Aug 3, 2023

ADDENDUM NO. TWO (2)

PROJECT: PV-TEC Building Remodel

DATE: JUL 23 DRAWING NO. **A5.1**

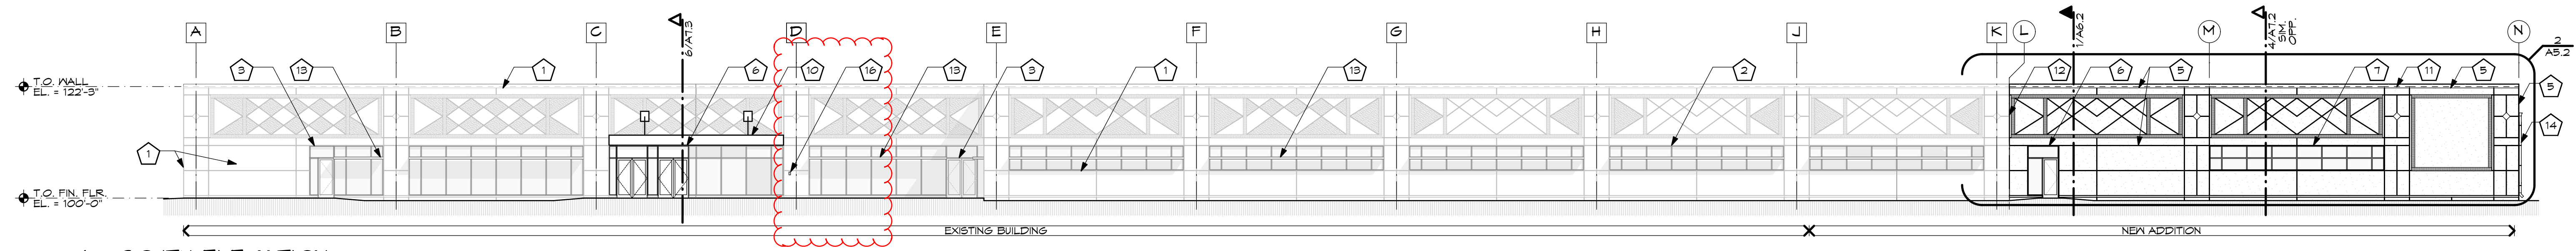
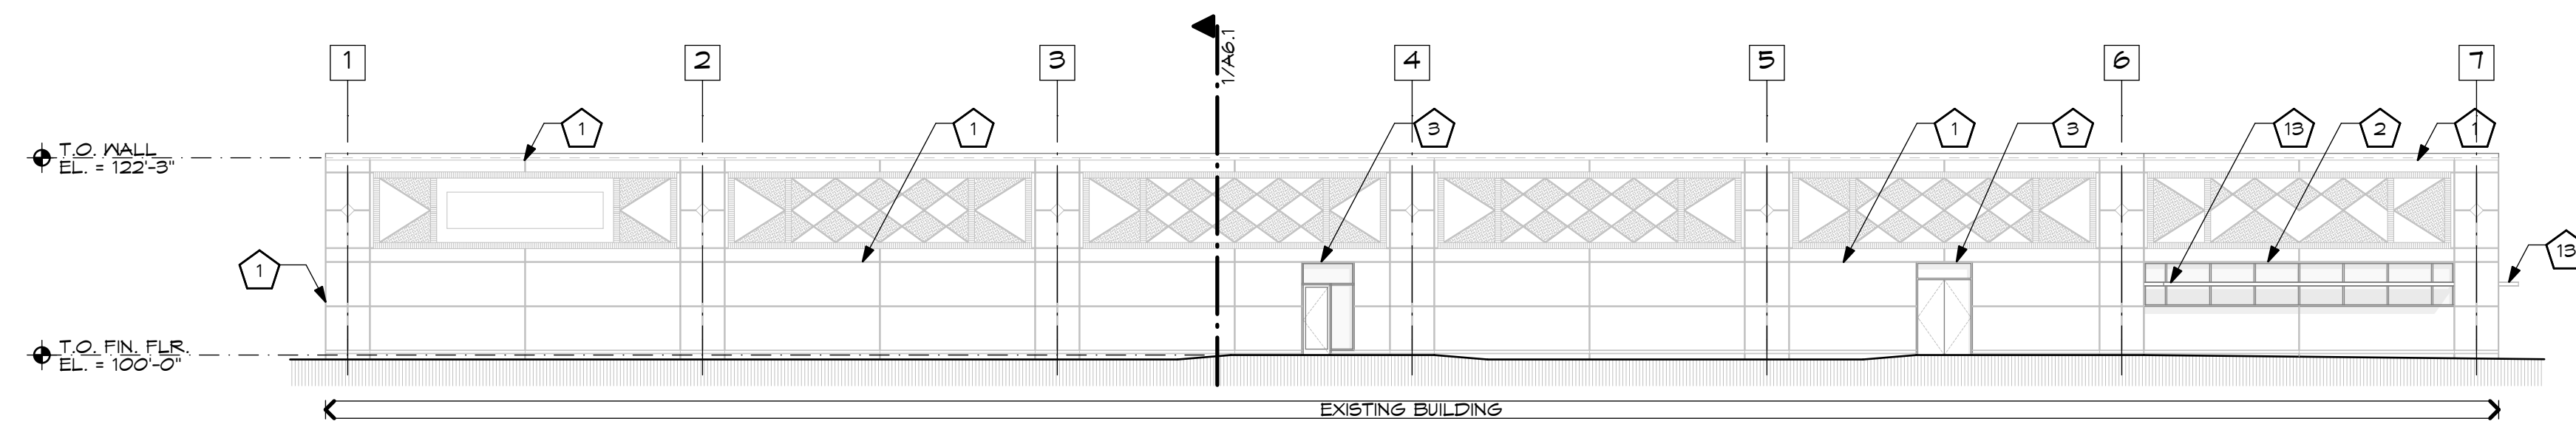
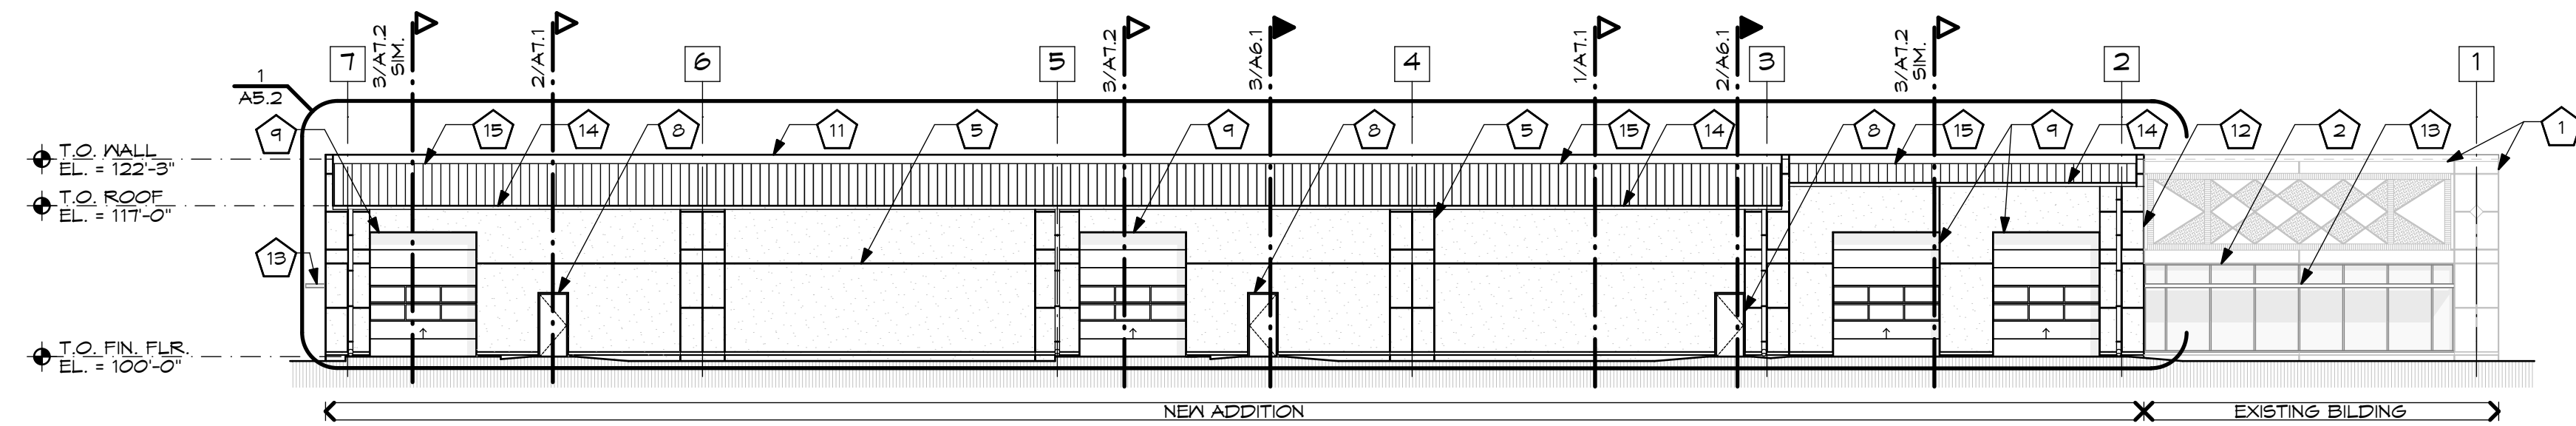
- D2 A5.1 – Relating to note 10, the canopy details in question are details 1 and 2 on sheet A7.4
- D3 A8.2 – The bottom column of the Finish Schedule is partially cutoff (finished for room 176), however the same column is repeated on the schedule to the right – see sheet A8.2
